# R132 Cycle Lane Study

Public Consultation Summary Report

Fingal County Council

Figure 3-1 - Safe Routes to School Layout Description

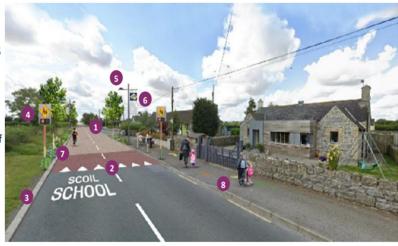
3.5. Among the submissions, issues were also raised about the facilitation of safe movements of students while arriving and departing the school.

- 3.13. However, additional measures will be incorporated into the design in order to further enhance safety for students in line with the NTA's "Safe Routes to School Design Guide" document. Some of these measures are outlined below:

- Road Markings A "School Ahead" marking to be provided along the R132 on both directions for informing motorists regarding location of school zone.
  - Traffic Calming Measures Virtual ramps without any vertical deflection to be provided at the gateway of the school and also at the start/end of the school zone. The R132 road in the school zone area will also be coloured using different textures. Specific pencil shaped bollards will also be provided in the school area to further reinforce the nature of it to drivers.

- **Signage** School Zone Signs will be provided to educate drivers about the school zone and cautioning about school children crossing.
  - Carriageway Width The width of the carriageway will be reduced to 3.1 m near the school zone. This will restrict the speed of the motorists and encourage the drivers to drive as per the posted and temporary speed limit.

- Pedestrian Crossing An uncontrolled pedestrian crossing will be provided close to the gateway
    of the school.
  - Pedestrian Path The design includes a shared path of 2m in each direction for cyclists and pedestrians. The shared pedestrian/cyclist path will be protected by bollards which will separate school students from vehicle traffic. This will allow students to walk safely between the drop-off parking location and school.

- Coloured surfacing applied within School Zone (buff colour HFS shown)
- Virtual ramp (i.e. no vertical deflection) at Gateway.
- Kerb on left side to define carriageway edge.
- Gateway totem on each side of road.
- Public lighting.
- School Zone Banner.
- Planting and trees.
- Micro-art in footpath.

Figure 3-2 - Kilhedge Lane ATC

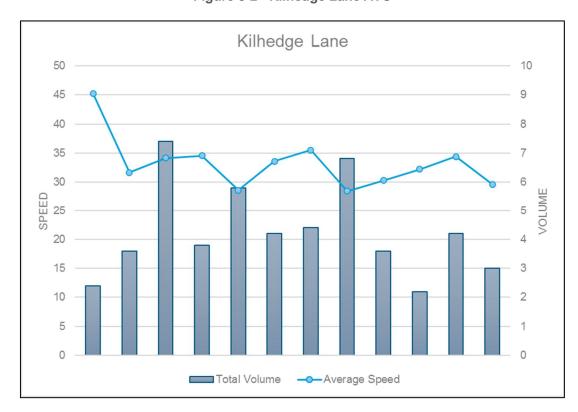
- 3.37. Multiple submissions proposed to limit the usage of the lane to pedestrian, cyclists and local access only.
- 3.38. Submissions also mentioned that the recent trimming of hedges was not sufficient to ensure safety of cyclists.
- 3.39. Submissions raised concerns about the lack of proposed traffic calming measures along Kilhedge Lane.

3.44. Traffic data was collected by use of an Automatic Traffic Counter (ATC) along this section of road close to the largest number of residences and is summarised in Figure 3-2 below. The data shows that volumes are very low on this road with most vehicles are likely accessing their residences only. There are a number of heavy vehicle movements which are most likely from agricultural vehicles accessing various fields located along the road. The AADT on this road is approximately 76 vehicles. Average speeds are also low at around 30 - 35 km/h which is as expected given the narrow carriageway width and horizontal geometry along the road.

Figure 3-4 - Link Type Option 4

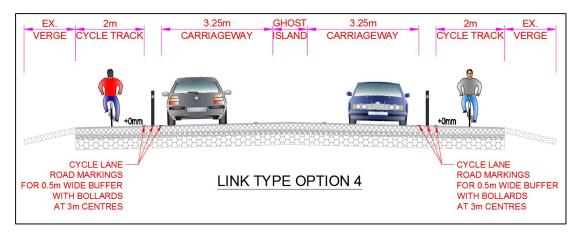
- 3.58. Multiple submissions suggested not using bollards for the cycle track. Submissions have given examples of inconvenience caused due to existing bollards at Rivervalley Road, Swords and the discontinuation of bollards at Griffith Avenue. Many submissions also raised concern that bollards will impact the natural beauty of the stretch of the road.
- 3.59. Submissions also suggested providing a two-way cycle track on one side of road, rather than a single lane in both directions.

- 3.66. The assessment identified Link Type Option 4 At Grade Cycle Track with Bollards and Buffer as the preferred option. This option best met the scheme objectives by providing a safe and attractive dedicated cycle/pedestrian facility which will significantly improve sustainable mode options in the area. Link Type Option 4 provides the best balance of attractiveness and safety for all road users considering the existing road character and semi-rural location while minimising costs and maintenance issues. Given the 60 km/h speed limit on this road, bollards are required in order to meet the requirements of the National Cycle Manual for the provision of a cycle track as opposed to a cycle lane.

Figure 3-5 - R132 Proposed Speed Limits

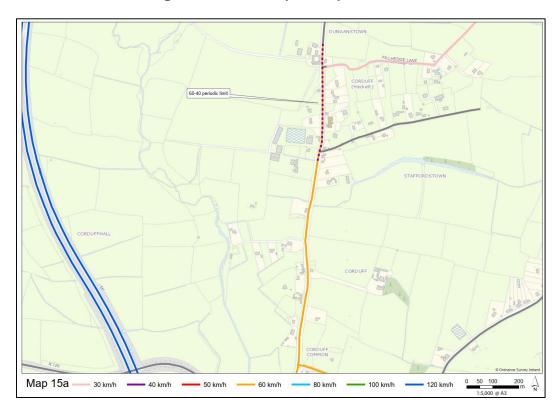
- 3.71. Submissions received have objected to the reduction of the speed limit along the R132.
- 3.72. Submissions also enquired about the proposed speed limit being considered for Ministers Road and Kilhedge Lane.

- 3.81. To install a cycle path along an 80 km/h road would require a separation distance zone of a minimum 2 meters between the road edge and cycle path to be in compliance with TII's national design standards. This would require land take along sections of the R132 that would significantly increase the cost of the project and delay the expansion of cycle network in Lusk and the surrounding area. In addition, a 60km/h speed limit along the R132 will improve road safety for all road users.
- 3.82. The proposed speed limit along different links are shown in the figure below. The speed limit along Kilhedge Lane has recently been adopted as 30 km/h while changes to the speed limit between Kilhedge Lane and Quickpenny Lane on the R132 from 80 km/h to 60km/h and along Ministers Road from 80 km/h to 50 km/h have been submitted and are currently waiting for approval.
